**CASE NO:** 2025-0038

**REQUEST:** Conditional Use for a Development Master Plan (Alpenglow Residences).

SUBJECT:           Alpenglow Residences  
                      Development Master Plan

# Alpenglow Residences Development Master Plan

SITE PLAN PHASES 1 & 2

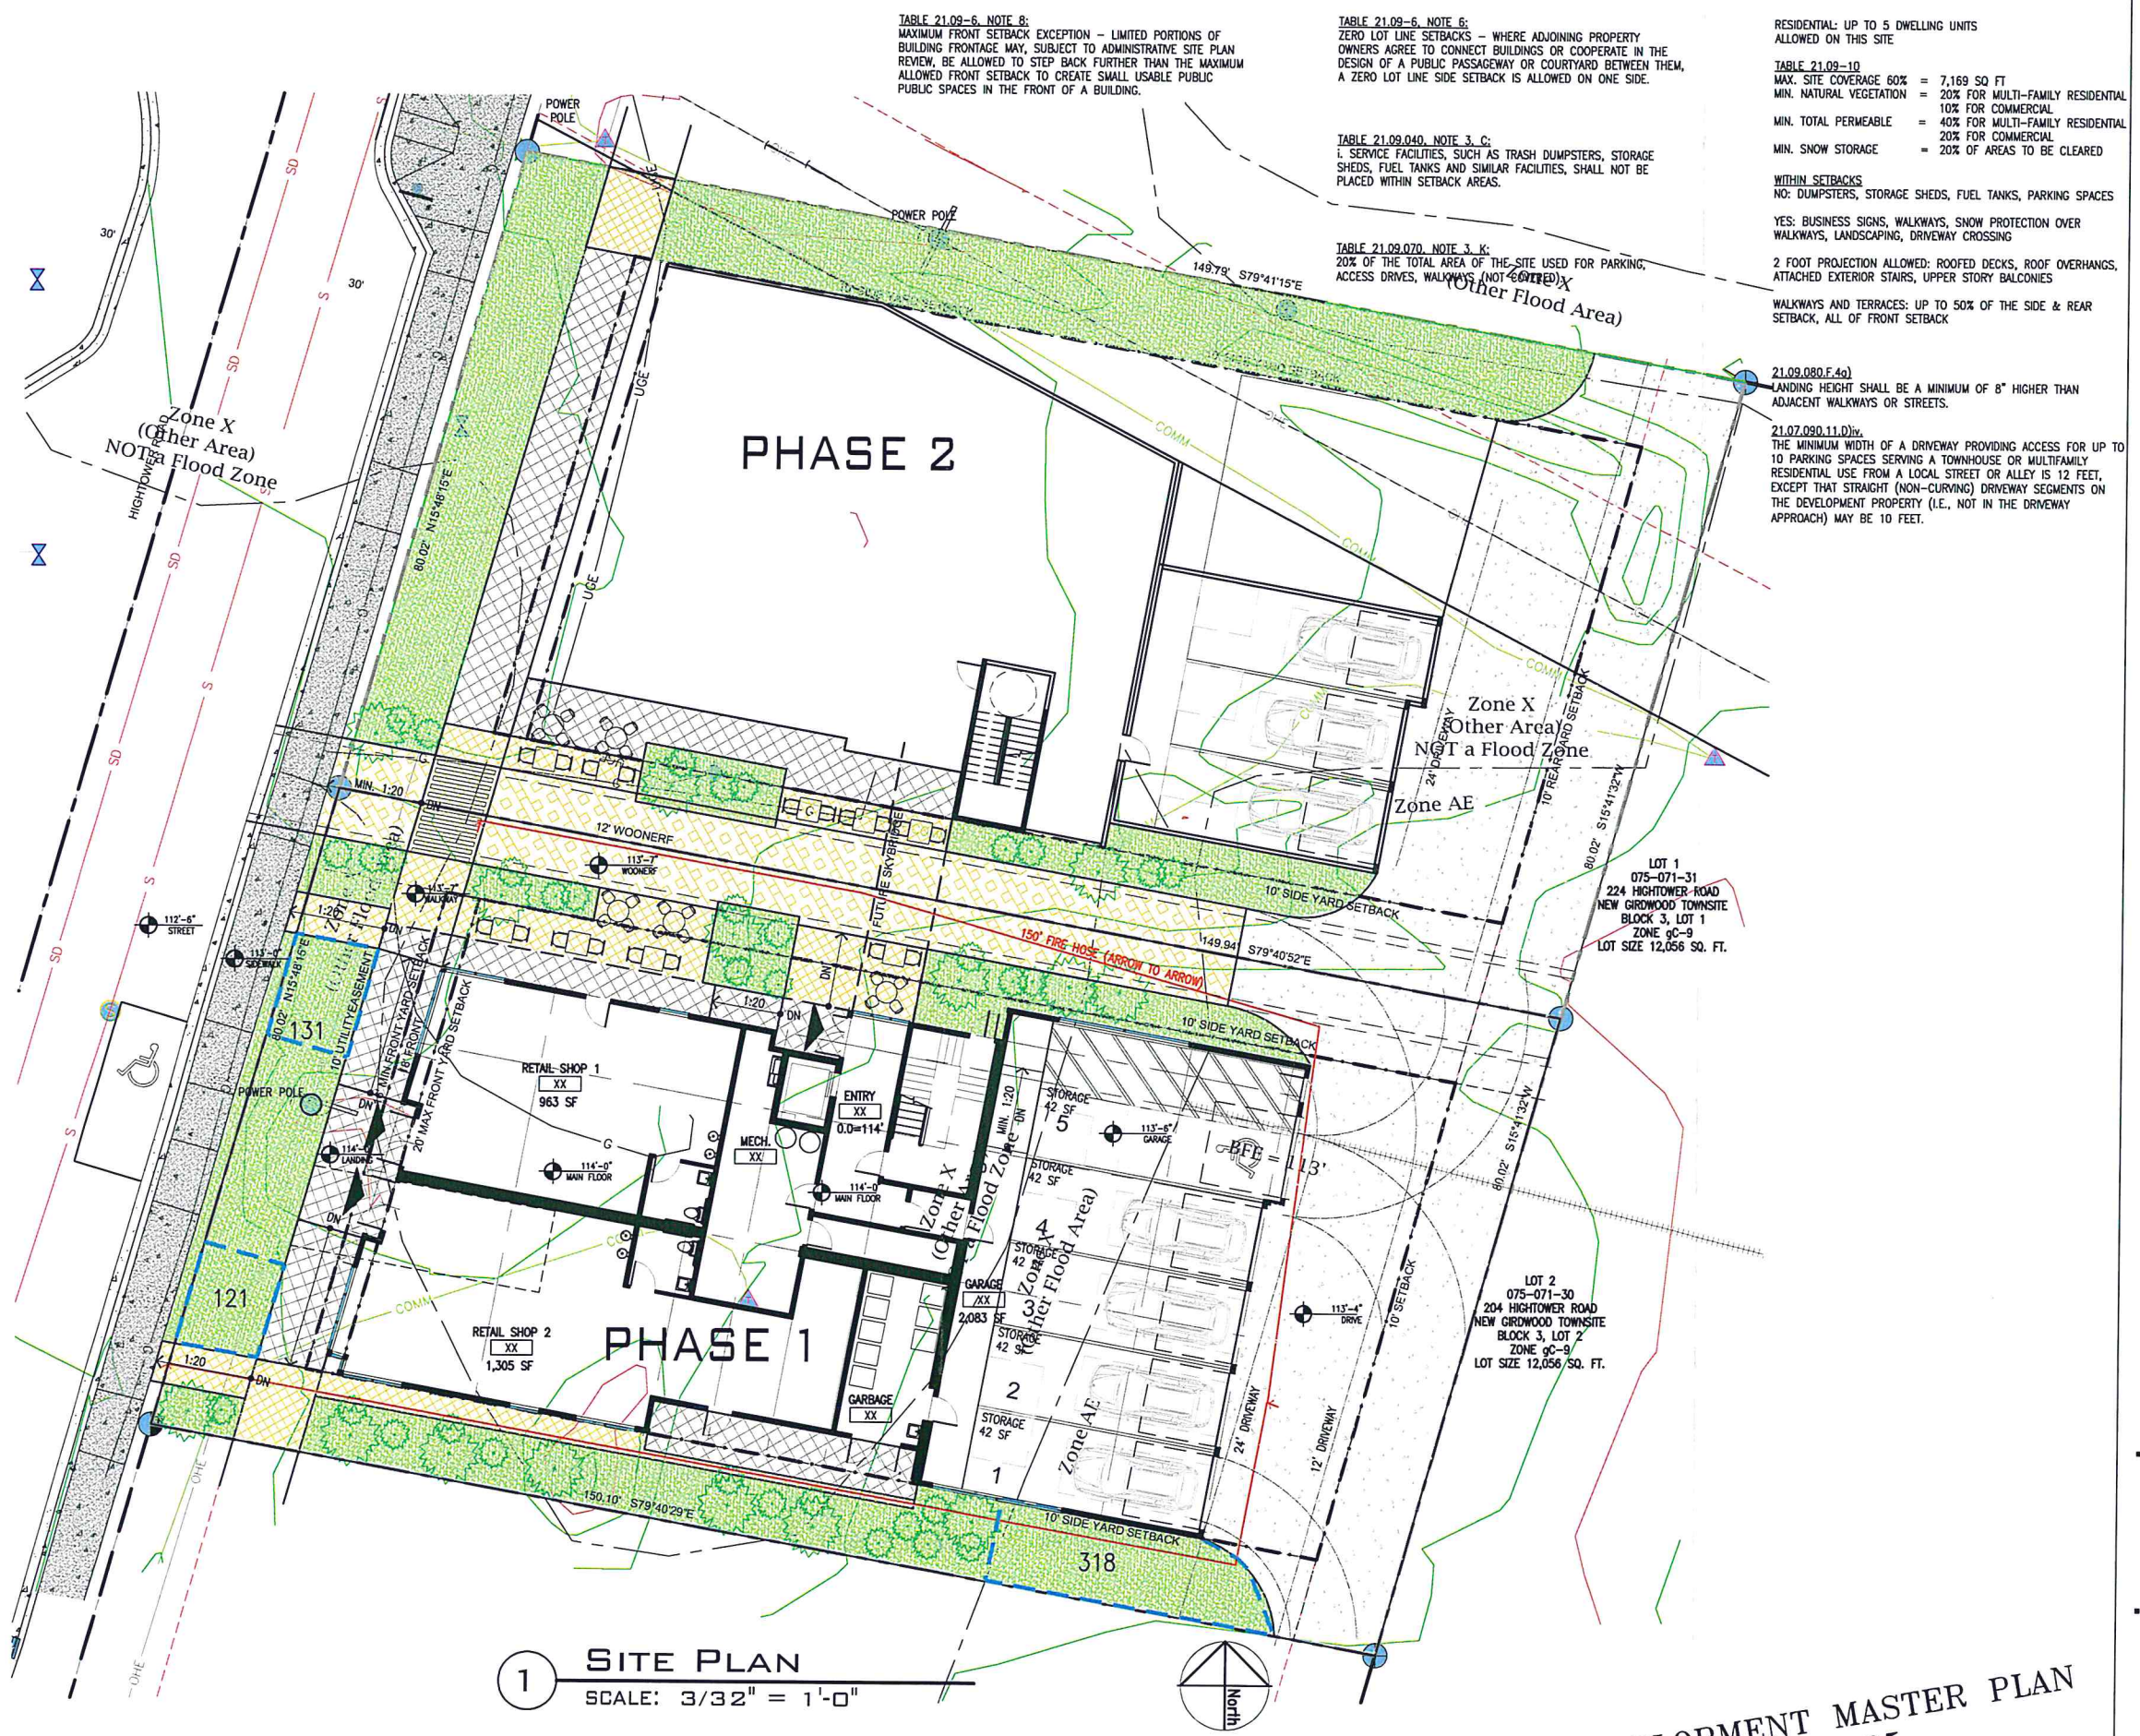
Paul LaFrance – shared access agreement. Snow storage in Southeast corner, make sure it does not drain into the neighbor's property. Snow storage can happen under the power line that is heavily encumbering the property. Do not show snow storage in required landscaping areas.

Planning supports the design deviations and setbacks. Driveway and flood plain discuss with Steve Ellis.

**A1.1**

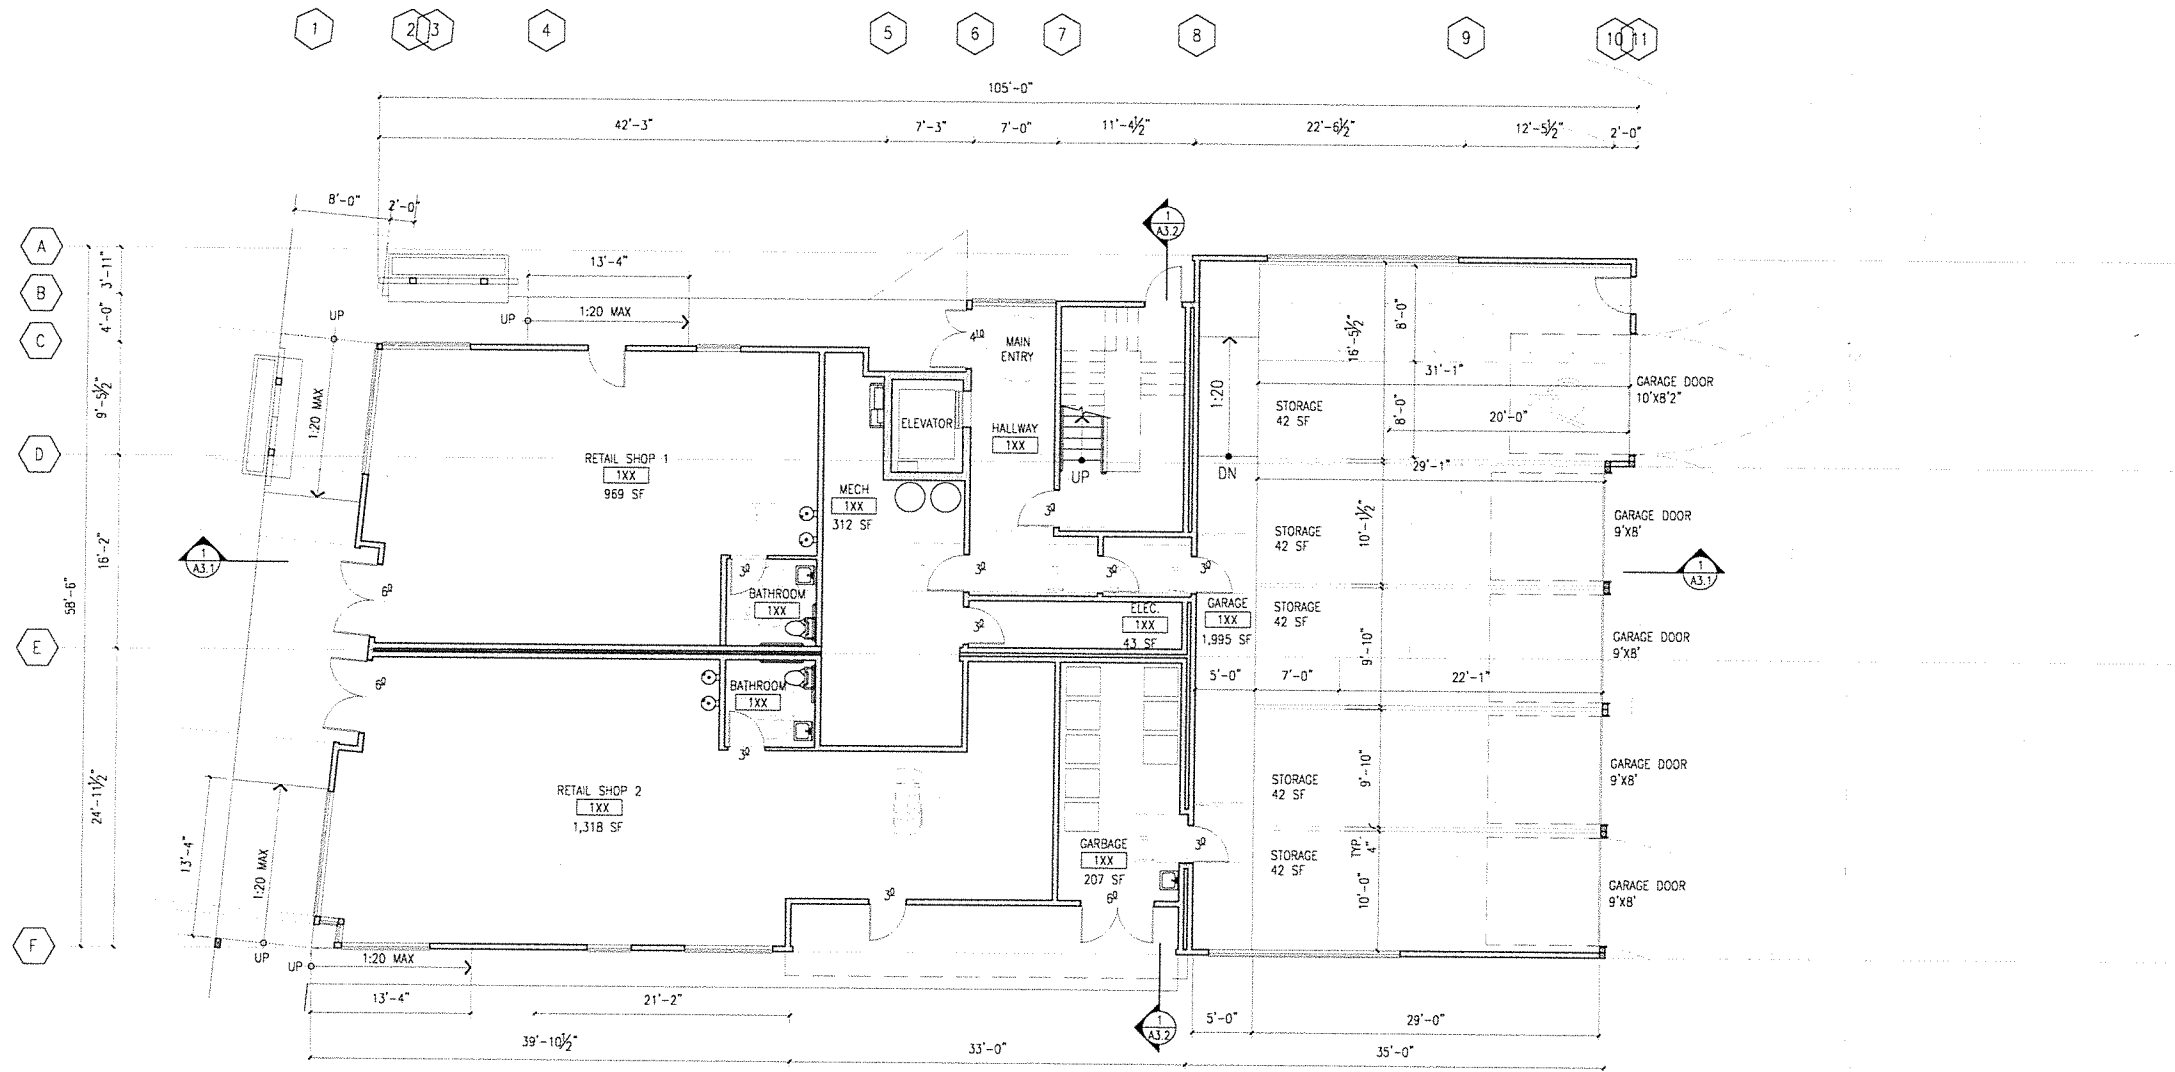
- DESIGN ALTERNATIVE: East and west (Hightower Road) facing walls may have an alteration in alignment of two feet in depth from the plane of the referenced wall. See architectural plans A1.1. The design meets all the other requirements of this standard.
- Commentary: This standard cannot be met at the wall facing Hightower Road. As noted previously, the effective minimum setback from the property line is 18 ft and the maximum front setback in this district is 20 ft. This calculation leaves only 2 ft of depth for alteration of alignment.

The intent of this code section is to reduce the visual mass of a building by introducing changes in wall plane. The east wall faces away from the street and the neighbors, therefore it is not readily visible to the public. The proposed design meets the standard.
